Proposed Alex Avenue Public School, 28 Farmland Drive, Schofields NSW 2762

Richard Crooks Constructions Pty Ltd 10 September 2019

19175_SAR155

Site Audit Statement

Figure 2

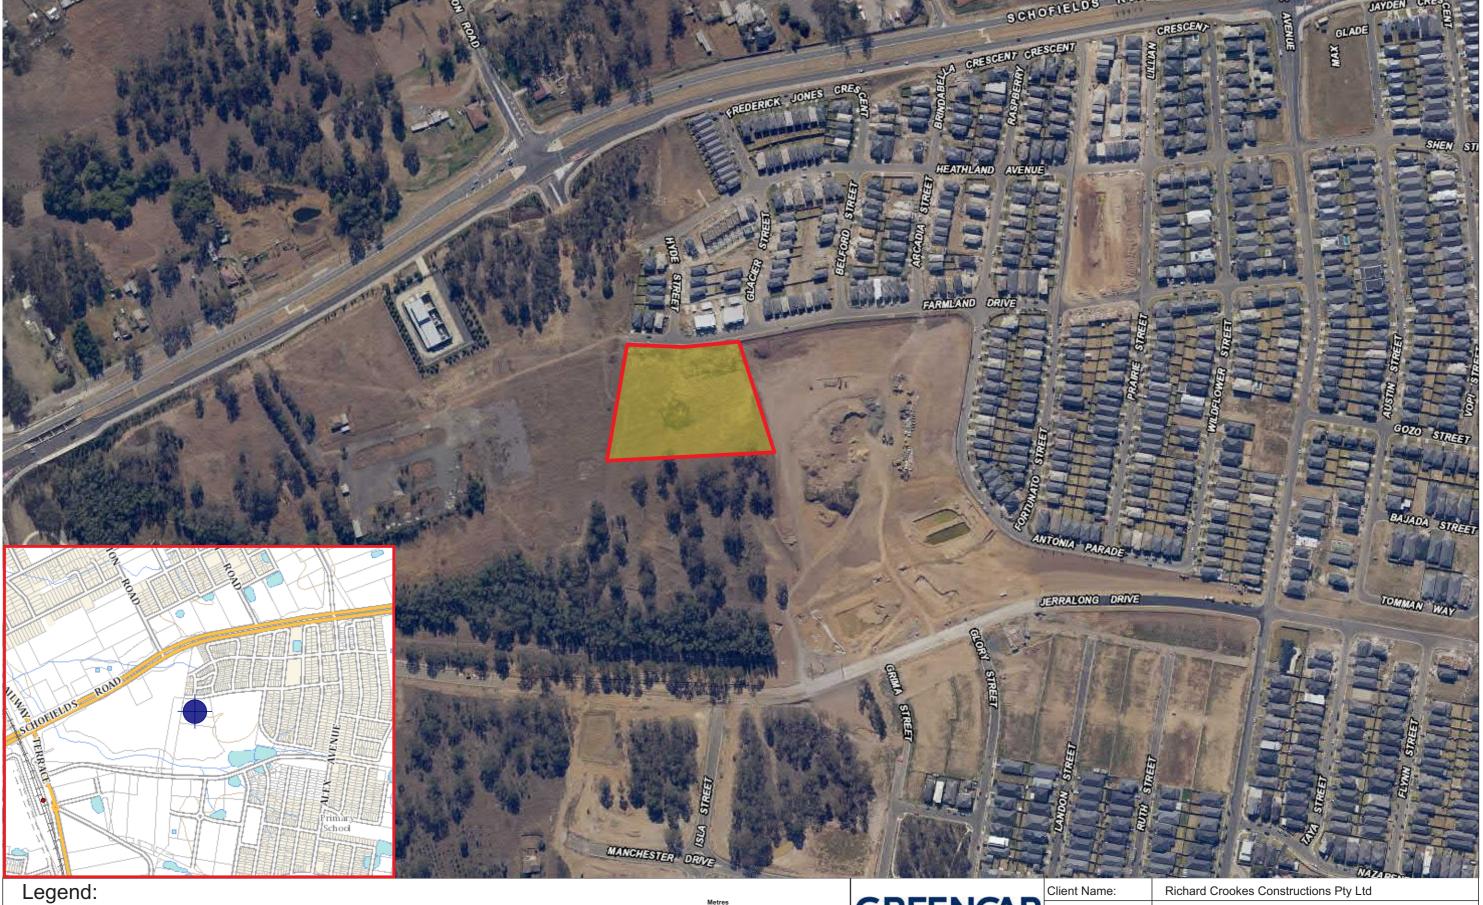
- 3. Section 2.4.3 (presence of drums/chemicals, waste and fill material): Figure 2 shows that foreign material was observed within the exposed soils in the northern portion of the site. Whilst noting that three of the Greencap's test pits (TP1, TP2 and TP5) were located within this area, the Greencap report did not mention or record the presence of foreign materials within exposed soil in the northern portion of the site. Greencap to confirm whether or not foreign materials are located in that portion of the site and whether or not this is acceptable aesthetically on a primary school site.

- b. As discussed in Comment 3, foreign materials were previously observed in the northern portion of the site. Please confirm whether this was observed onsite and actual nature of foreign materials across the site and whether aesthetically this is acceptable for a primary school site.

Reference	Greencap Response
b. As discussed in Comment 3, foreign materials were previously observed in the northern portion of the site. Please confirm whether this was observed onsite and actual nature of foreign materials across the site and whether aesthetically this is acceptable for a primary school site.	Foreign materials (e.g. terracotta pieces) that do not pose a contamination risk, may remain in-situ underneath sealed surfaces on site (e.g. Building footprints, pavements or asphalt roadways). Garden accessible soils (top 100 mm in particular), on the other hand, are recommended to be cleared from foreign objects. Updated site condition: On 26 July 2019, Greencap conducted a detailed site walkover and observed fill material containing foreign materials were stockpiled towards the eastern section of the site (referred to as SP3, waste classification report is pending). Including SP3, on this day Greencap sampled six (6) different stockpiles and investigated an unexpected find (UF) of relatively small volume of (< 3m³) buried waste material (referred to as UF1, which consisted an old potential paint cannister ~ 10L volume, plastic sheeting, and terracotta—refer to Greencap's email dated 26 July 2019. We observed that the stockpiles on site were generally well managed and neatly separated from natural soils on site. We also noted that the soils on-site (predominantly natural) have been moved towards the west of the site as part of a cut & fill plan, which was understood to be the source of the re-worked natural soil surface towards the west. After the inspection and clearance of UF1, 3 validation samples were collected from the footprint of UF1 and sent to the NATA laboratory to be placed on hold. Should the chemical testing results of the excavated UF1 material (SP4) indicate presence of contamination, these samples will need to be scheduled for relevant chemical testing. Furthermore, after UF1, 9 test pits were advanced in the western section of the site (Proposed Lot 1) to cover the re-worked natural soils nearby. Greencap observed re-worked natural material was consistent with the natural soils found on site and did not include any visual or olfactory evidences of contamination. At all 9 test pits, natural soils were encountered at depths ranging between 0.1-1.2 mBGL. The findings of this investigation ar

Figure 2

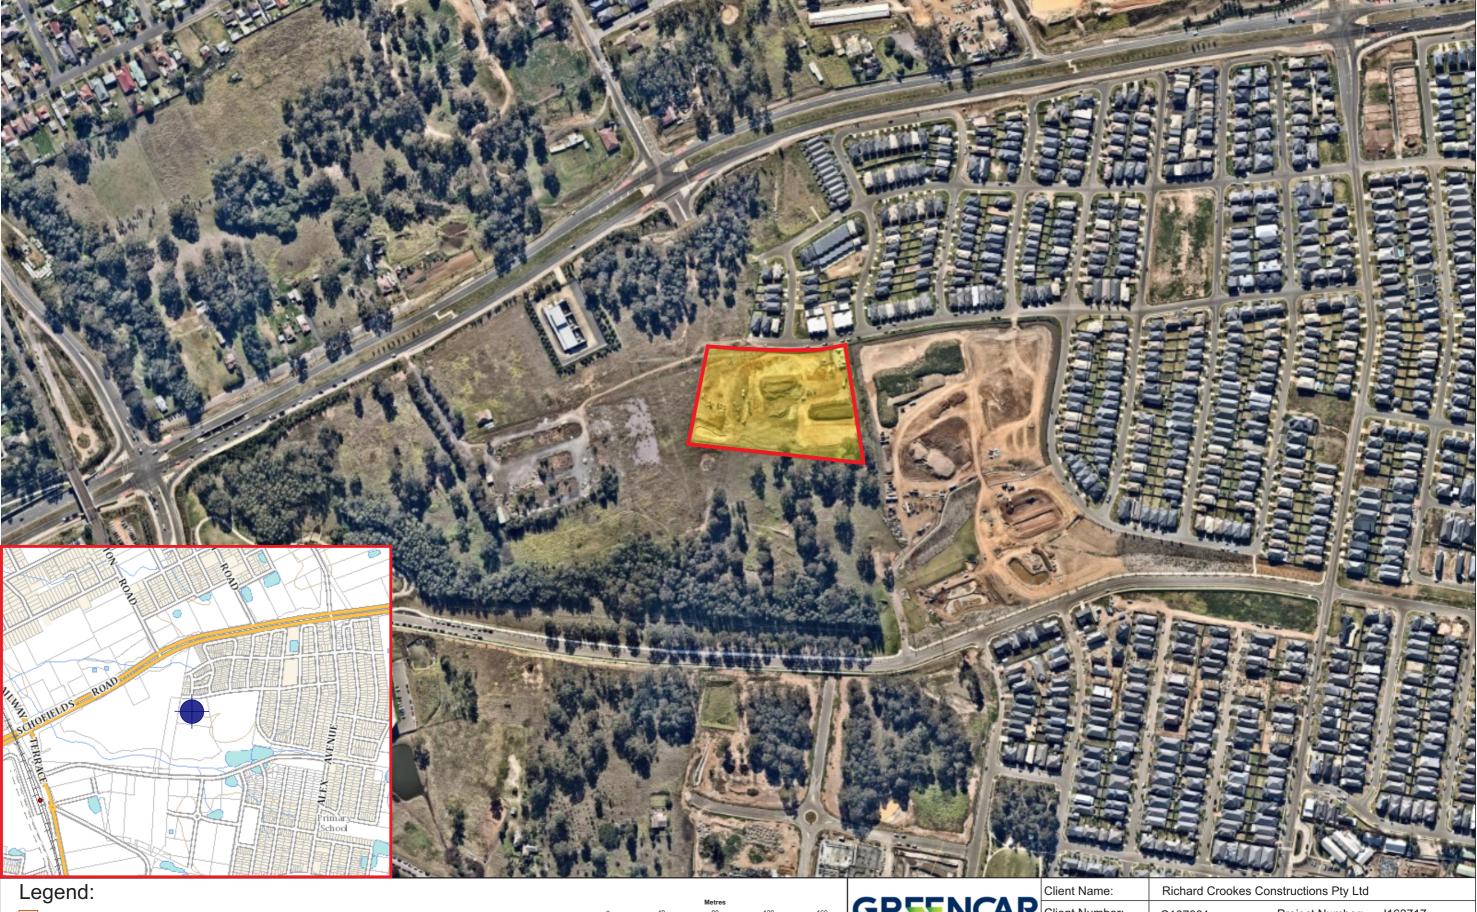
- a. Greencap states that 'the two stockpiles of fill material identified in the PSI report were located as described. Refer to Figure 3 for stockpile locations'. A review of Figure 3 notes that the two stockpiles were identified by Greencap were located further north and east from the two stockpiles observed by EIS during the PSI. Based on the EIS and Greencap figures, it appears that the two stockpile locations identified by EIS were closer to the Greencap's test pits TP6 and TP7 and the area to the immediate south of these two test pits. Please confirm if this interpretation is correct and that the area has been suitably characterised.

Reference	Greencap Response
a. Greencap states that 'the two stockpiles of fill material identified in the PSI report were located as described. Refer to Figure 3 for stockpile locations'. A review of Figure 3 notes that the two stockpiles were identified by Greencap were located further north and east from the two stockpiles observed by EIS during the PSI. Based on the EIS and Greencap figures, it appears that the two stockpile locations identified by EIS were closer to the Greencap's test pits TP6 and TP7 and the area to the immediate south of these two test pits. Please confirm if this interpretation is correct and that the area has been suitably characterised.	These stockpiles have been classified as GSW and are scheduled to be taken off-site. Greencap confirms this area has been suitably characterised.
